## ***Interactive comment on “A coincidence detection system based on real-time software” by Sindulfo Ayuso et al.***

Author's response:

Figure 2. Counting rate versus voltage for PMTs type 53AVP (Philips). Note the plateau below 1500 V and the crossing point of both curves in 1270 V (bias voltage chosen).

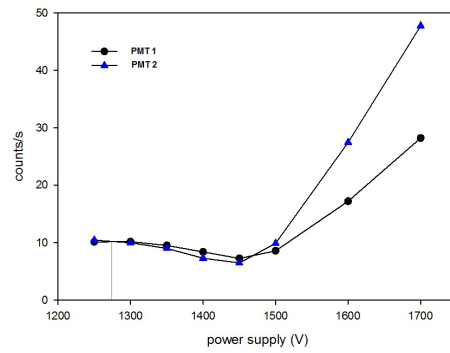
1. (p4 I5) Authors have to justify the choice of voltage of operation based on the experimentally determined PMT response.

We agree. A new figure 2 and the following paragraph have been added in page 4.

“We can see in Fig. 2 the variation of the counter response with the bias voltage for both PMTs used in the experiment. Bearing in mind they work in coincidence coupled

to identical scintillators, we have chosen 1270 V as optimal value because it is the point where both PMTs have the same response within the plateau.”

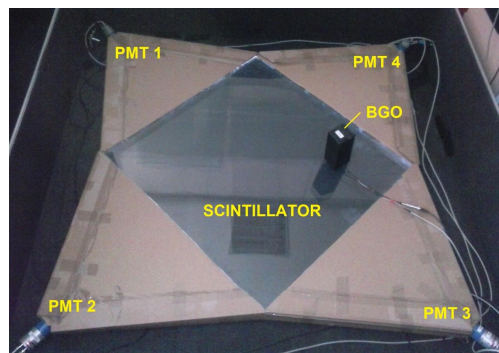
2. (p4 I14) A photo of this device is necessary

We agree. A photo has been added (new figure 3).

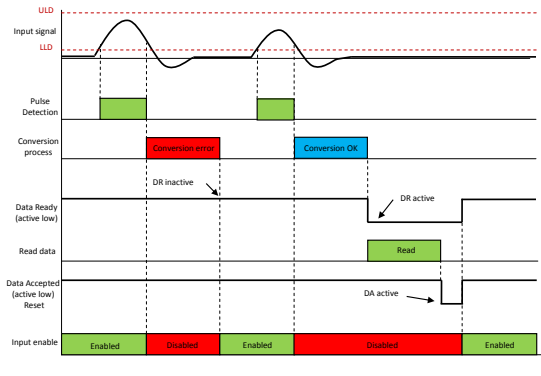
3. (p5 I25) This paragraph would be better understood if diagrams are used

We agree. Diagrams have been included (new figure 5).

Fig. 5. Figure 16

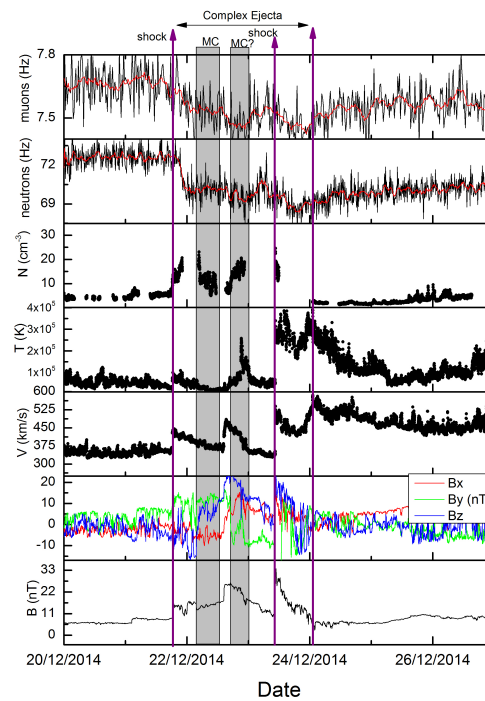
7. (p14 I17) Magnetic field rotations may only be seen when components are shown.

These do not appear in Fig 14.

8. (p14 l23) An estimate of the average response of both detectors and the reasons for that should be given. The decrease in the muon telescope is much faster than that of the NM. Authors must try to give an explanation for this.

Magnetic field rotation already was shown in figure 14. Please, see from bottom to top the second row. Nevertheless, the figure has been adapted to point out the magnetic field rotations by shadowing the adequate region. In addition, a new shock line and the probably location of the associated magnetic cloud have been marked in the updated figure (now, Fig. 16). The text has been slightly reworded according to the new figure.

We don't know what exactly the referee means with average response. We have explained at the beginning of this section that, because of CaLMa cut-off rigidity, the energy of primary CR that produce neutrons measured in CaLMa is higher than 7 GeV when protons are the primary CR. The CaLMa background count rate is 72.62 Hz. For the muon telescope, the expected energy for primary CR is higher than 10 GeV and its background count-rate is 7.66 Hz. Regarding to the second part of the referee's comment, in our opinion, what it is observed in figure 14 is just the opposite, a sharp decrease in neutron and a softer decrease in muons, as could be expected for primary cosmic rays with a higher energy threshold. Nevertheless, in order to clarify it, we have re-written the last paragraph in section 6.1.

"The good agreement between the muon and neutron data, presented in Fig. 16, validates the software-based coincidence system used to acquire the muon data. Both of them show a clear response to the passage of interplanetary disturbances. The difference in their count-rates decreases observed by both instruments in shape (faster, sharper and deeper decrease in CaLMa) and in magnitude is likely related to the different energy of the primary cosmic ray producing the secondary neutrons and muons observed at ground level, as could be expected when the primary cosmic ray energy threshold for CaLMa (neutrons mainly) is about 7 GeV and for the muon telescope is

about 10 GeV."
